# UNITED STATES PATENT AND TRADEMARK OFFICE

APPLICATION NO.	FILING DATE	FIRST NAMED INVENTOR	ATTORNEY DOCKET NO.	CONFIRMATION NO.
10/605,528	10/06/2003	Kazuhiro Takeda	SIC-03-036	2527

<b>Office Action Summary</b>	<b>Application No.</b>	<b>Applicant(s)</b>	
	10/605,528	TAKEDA, KAZUHIRO	
	<b>Examiner</b>	<b>Art Unit</b>	
	Gunyoung T. Lee	2875

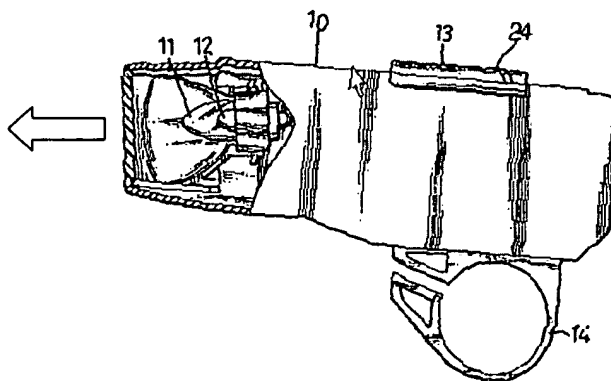
3. Claims 7-8 are rejected under 35 U.S.C. 103(a) as being unpatentable over Lin (US 5,690,410) in view of Kennedy et al (US 2,747,078) and Sun et al. (US 5,477,425).
4. In regard to claims 7-8, Lin discloses a bicycle lighting system having:
  - A computer housing (10) adapted to be mounted to a bicycle (32);
  - A computer/microprocessor (20) housed within the computer housing (10);
  - A display (13) housed within the computer housing (10) and inclined rearwardly (as shown in the picture on page 3);
  - A lighting device (11) housed within the computer housing (10) and controlled by the computer/microprocessor (20) (Col. 2, lines 37-42);
  - Wherein light emitted by the lighting device (11) is directed forwardly outside of the computer housing (10) (as shown in the picture on page 3);

- An externally mounted device (21) being a conduit (wires) to the computer housing (10).

5. Lin does not expressly disclose that the housing includes a conduit coupler for the wire (conduit), and light is directed laterally outside of the housing. Kennedy discloses a lighting unit (2) having a light housing (10) with a conduit coupler (74) for a conduit from an externally mounted device (11), and Sun et al. disclose a bicycle lighting device (Fig. 7) in which light emitted by the lighting device is directed laterally (11) outside of the lighting device (1). Therefore, it would have been obvious to one of ordinary skill in the art at the time the invention was made to use the conduit coupler of Kennedy and the lateral lighting as shown in Sun et al. for the bicycle lighting system of Lin, for the purpose of improving the safety of the rider by providing illumination around as well as in front of the bicycle, and increasing the durability of the lighting device by using the conduit coupler which protects the wires (conduit) from overheating or breaking while the bicycle is skidding on the ground in an accident.
